Minutes of discussions held during Pre-bid Conferences held on 08.08.2019 & 21.08.2019 and site visits against Global e-tender no. 06(AS)/2019 for procurement of one Drive-through Container Scanners(Rail)to be installed at JNPT, Nhava Sheva

SUPPLY, INSTALLATION, COMMISSIONING & MAINTENANCE OF 1 (ONE) DRIVE-THROUGH CONTAINER SCANNER (RAIL) SYSTEM
Global E-Tender No. 06(AS)/2019 dated 15.7.2019
CLARIFICATION TO QUERIES PROVIDED IN PRE-BID CONFERENCE HELD ON 08.08.2019 AND 21.08.2019

Schematic Layout of Drive-through Container Scanner (Rail) Facility

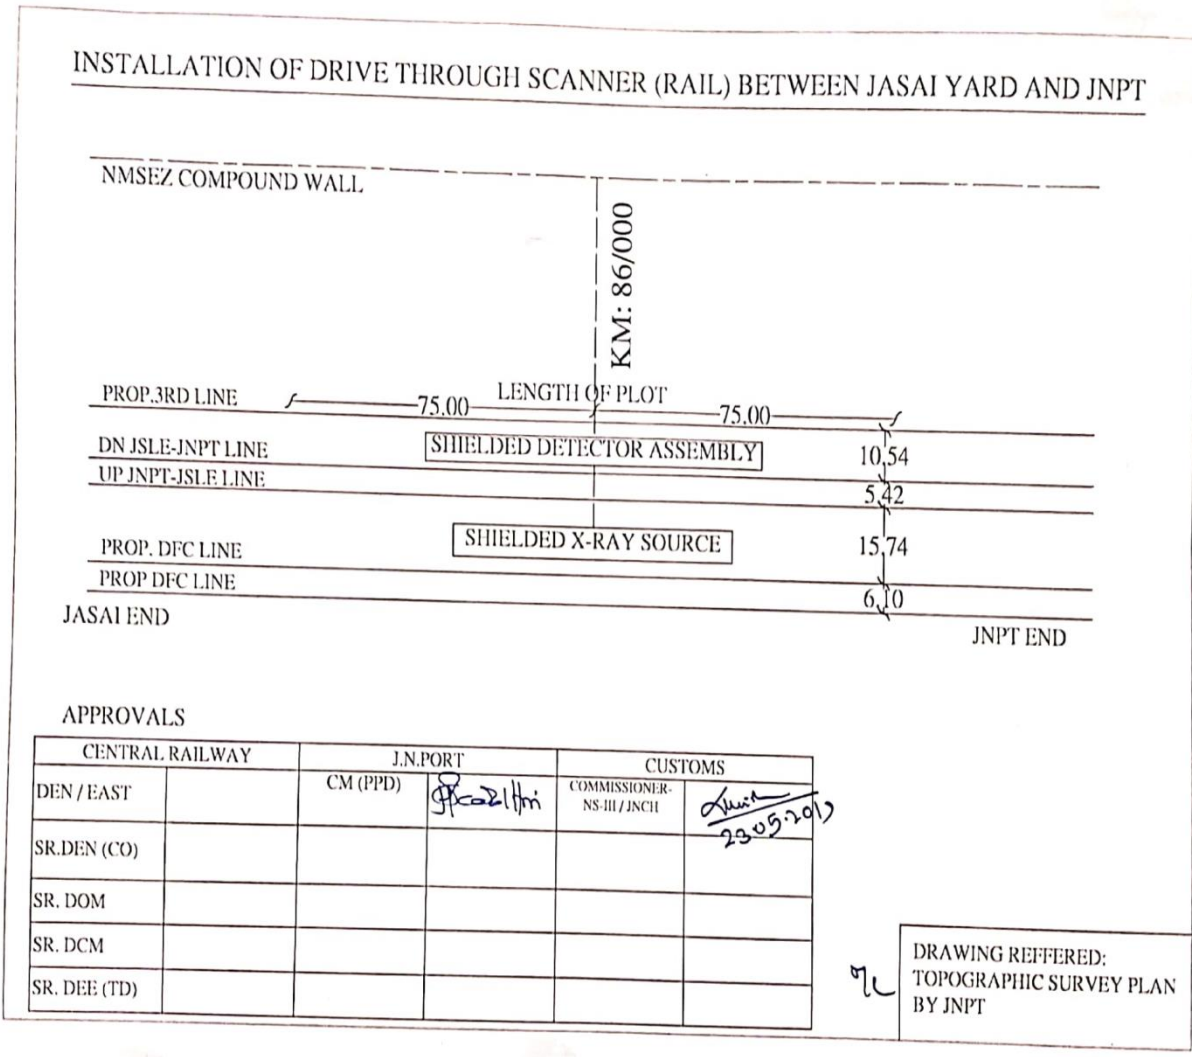
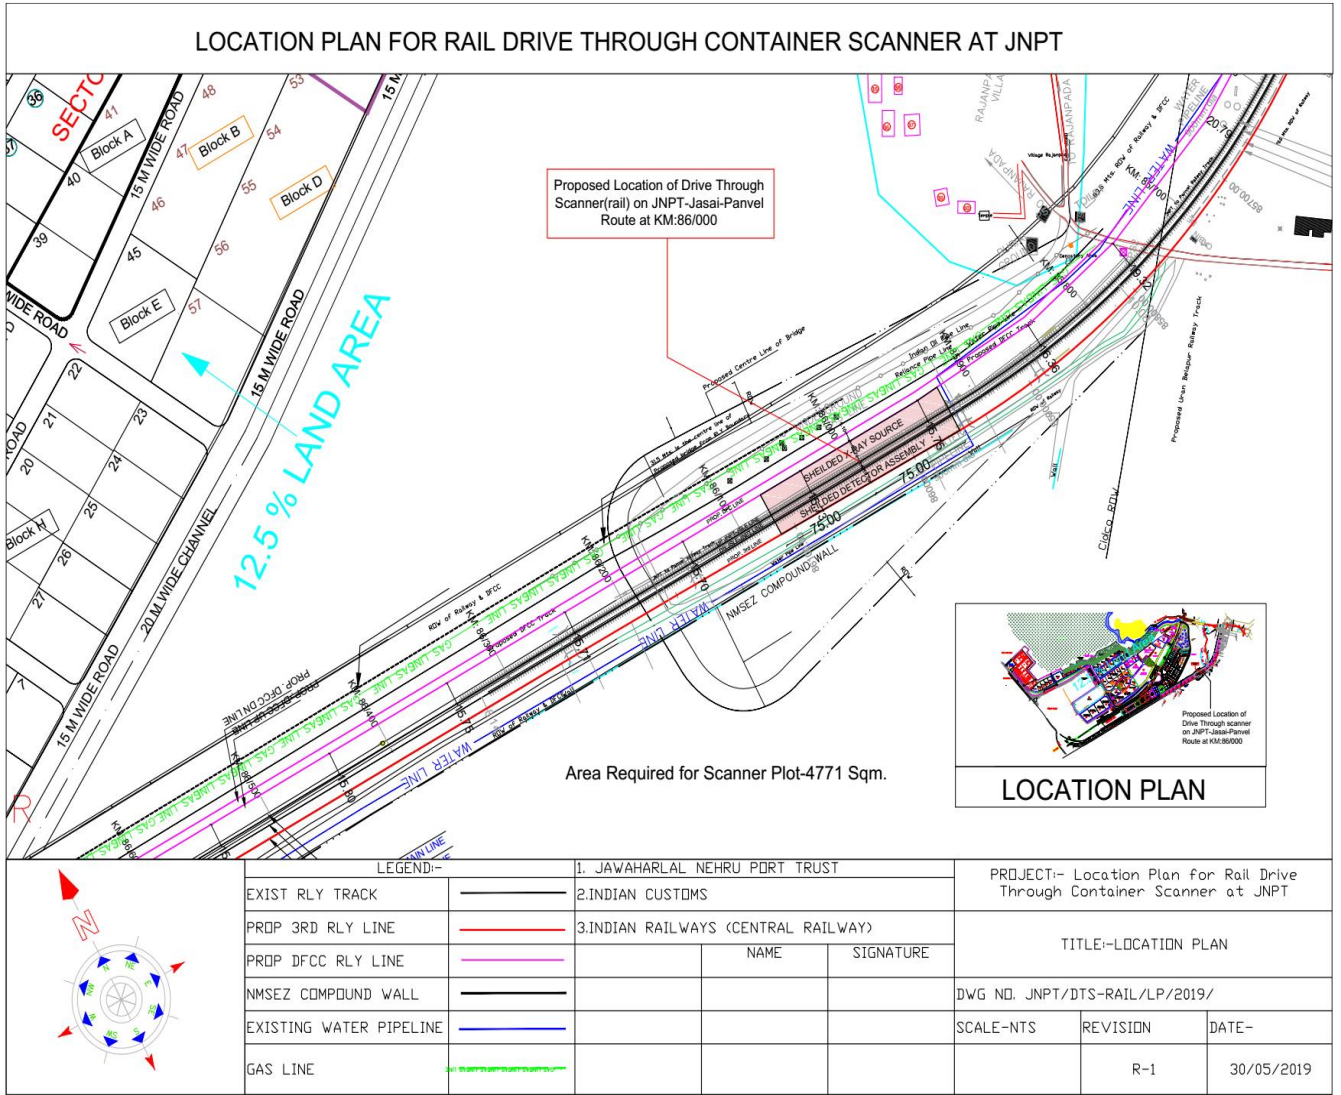
R25	47	4.11	A schematic arrangement	Please provide schematic	<i>Schematic arrangement is</i>

R50	48	4.11 (iii)	(A schematic arrangement is shown in Appendix - XX)	Request purchaser to provide drawing showing arrangement of existing and future tracks and any underground utilities in the vicinity of the scanner.	<i>Schematic arrangement attached. Annexure II (iv)</i>
R51	48	4.11 (iii)	No construction shall take place within 2.3 meters from the centreline of the track.	Request Purchaser to explain if this figure applies to temporary works (E.g. shuttering works, scaffolding...etc.)	<i>No construction, at all times – including temporary, shall take place within 2360 mm from the centre line of the tracks.</i>
R52	48	4.11 (v)	Technical Requirement – System	It was understood during site visit meeting on 16.08.2019 that the number of trains that travel on each track per 24 varies between 16-32. Request purchaser to confirm.	<i>Number of trains on each track may be up to 24 per day.</i>
R53	49	4.11 (xv)	Electrical &	Request purchaser to clarify provisions	<i>May be read as:</i>

(iii)	is shown in Appendix - XX)		<i>attached. Annexure No II (iv)</i>
R26	48/49	4.11 (xii) c)	Boundary Management - The area under scanner facility should be provided with a barrier.	Please define where the barrier would be installed and for what purpose?	<i>Requirement of barrier may get evolved during detailing of the scanner facility to create exclusion zones and the same time interlock with Railways Signalling and X-Ray source.</i>
R27	48	4.11 (viii)	Designs, Drawing approvals	Here the requirement is to obtain approvals from various Government agencies including Indian Railways. This may lead to unexpected delays and unforeseen technical requirements that cannot be visualised at the time of bidding. It makes more prudent towards the overall benefit of the project that interaction and approvals from Indian Railways must be in the scope of Purchaser. The Supplier will work in coordination with the Purchaser and will provide all required assistance to the Purchaser.	<i>Refer response in Sl. No. R 12</i>

<i>to split the images, in case of two containers on a wagon.</i>
N29	Section IV	4.10 (xxix), Page 45	Security & Safety c) Provisions should be made to protect the scanner system from being damaged by any accidental derailment.	Please confirm more detail how to protect the scanner system from being damaged by any accidental derailment.	<i>Refer response in Sl. No. R 31.</i>
N30	Section IV	4.11 (iii), Page 47	a) Scanner will be installed across two-track rail system. These are fully operational, presently with diesel locomotives, but soon to be electrified with 25 KV AC overhead traction system passing at a height of ___ meters. b) Centre to centre distance between the existing two tracks is approximately 5.42meters. c) Centre to centre distance between Track-2(down track/ import) and proposed 3rd line is approximately 10.5 meters. d) Centre to centre distance between Track-1 (up track/ import) and proposed DFC line is approximately 15.5 meters.	Please confirm the height of electrified traction or the height limit. Also the necessary appendix should be provided. Appendix XX not mentioned in the tender. Please clarify.	<i>Electrified traction line is at 6.525 mtrs from the rail level. Annexure II(iv)- Schematic arrangement is attached.</i>

Project Name:
 CONSTRUCTION OF PROPOSED ROAD OVER BRIDGE IN/ADJ OF LEVEL CROSSING NO. 03 AT 85.6-7 ON JNPT-PANEL SECTION.

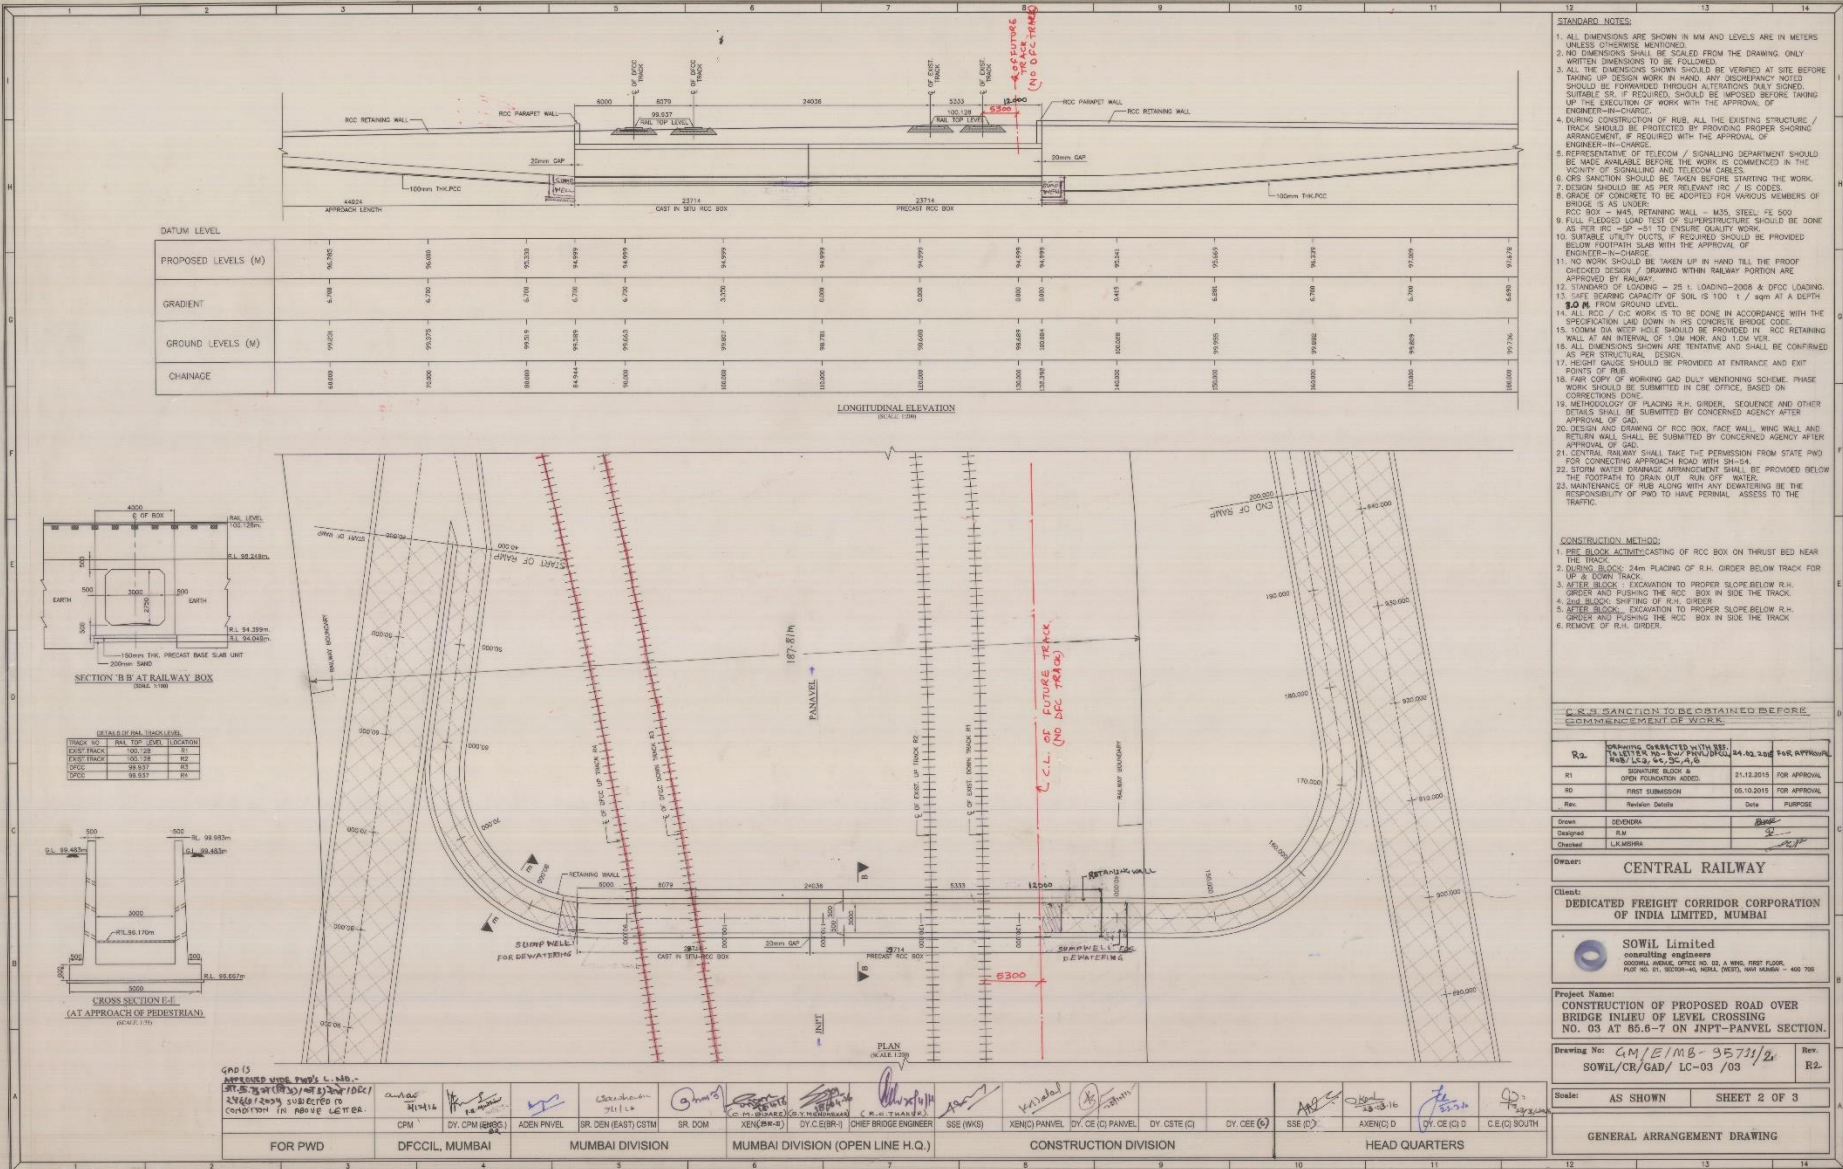
R46	30	3.11e	No damage (underground/over ground) occurs to the existing structures/installations and services there.	Request purchaser to provide drawing showing underground services near scanner facility.	<i>GA drawing of zone of interest is attached as Annexure III(i)</i>
R47	30	3.11e	Scanner facility might have to be constructed in	Request purchaser to provide exact location of proposed rail scanner facility (Provide	<i>Exact coordinate will be provided to the successful</i>

tender document.	
N36				Please provide the confirmed location of remote inspection facility/building. Is it required to construct new building or to modify in the existing building. If yes, please also provide the layout of existing building for our understanding for the purpose of workstation layout.	<i>Layout of new building is under preparation. Vendor to provide the space requirement which would be suitably incorporated by the Purchaser. Refer to response to R4.</i>
N37				We request to please provide the copy of topographical data/report, geotechnical survey report, including soil data and flood level of the site area, identification of underground pipes, fuel lines, gas line, any underground electrical cables, OFC/communication cables, pipe crossing, drainage line which are passing through/nearby the existing tracks of Drive through Container Scanner (Rail) System site, if available with Port Authorities/DOL/Railways.	<i>GA drawing & geo-technical data as available are attached as Annexure III (i) to MOM</i>
